# Access Compliance Report

## Public Rights-of-Way

Intersection ID: 10023893	Main Street: COMMUNITY_HOUSE_RD	Cross Street: N/A	Location: NE
ADA ID: 1C32E3F6A725	Ramp Type: PerpDiag	Initial Pass/Fail: Fail	Overall Compliance: No
Codes/Mitigation Info/Possible Solution		Field Measurements/Component Compliance	
Severity Score: 8.75

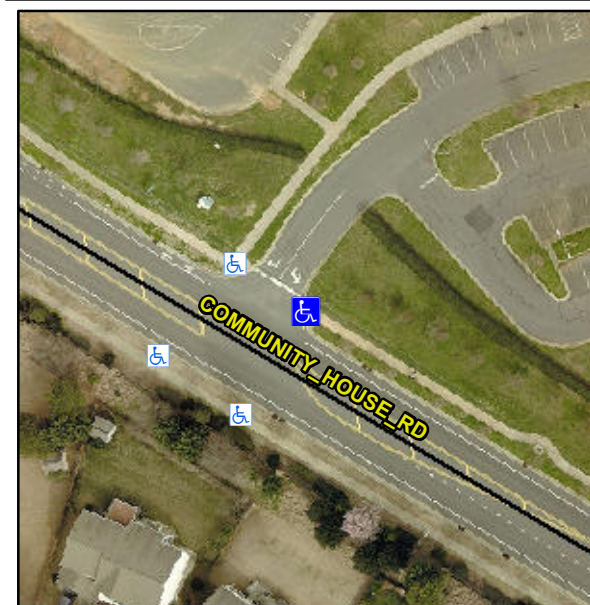
**Not Found, R304.5.1**

Compliance	Description	Data	Compliance	Description	Data
N/A	Ramp Length (in)	96.0	Yes	Ramp Slope (%)	5.9
No	Ramp Width (in)	45.0	Yes	Ramp XSlope (%)	1.3
N/A	Flare Type LT	N/A	N/A	Flare Type RT	N/A
N/A	Flare Slope LT (%)	N/A	N/A	Flare Slope RT (%)	N/A
N/A	Flare Traversable LT?	N/A	N/A	Flare Traversable RT?	N/A
N/A	Landing Length (in)	N/A	N/A	DWS Provided?	N/A
N/A	Landing Width (in)	N/A	N/A	DWS Contrast?	N/A
N/A	Landing Slope (%)	N/A	N/A	DWS Length (in)	N/A
N/A	Landing X Slope (%)	N/A	N/A	DWS Full Width?	N/A
N/A	Landing Curb? (Y/N)	N/A	N/A	DWS Offset (in)	N/A
N/A	Shared Landing?	N/A			
N/A	Gutter Ponding?	N/A	N/A	Gutter Slope (%)	N/A
N/A	Gutter Lip Ht (in)	N/A	N/A	Gutter X Slope (%)	N/A
N/A	Painted X Walk1?	No	N/A	Painted X Walk2?	No
	X Walk 1 Direction	To NW		X Walk 2 Direction	To SW
N/A	X Walk 1 Width (in)	N/A	N/A	X Walk 2 Width (in)	N/A
	X Walk 1 Slope (%)	0.2		X Walk 2 Slope (%)	2.8
	X Walk 1 X Slope (%)	1.2		X Walk 2 X Slope (%)	0.9

**Remove & Replace Curb Ramp With Two New Directional Ramps or Equivalent.**
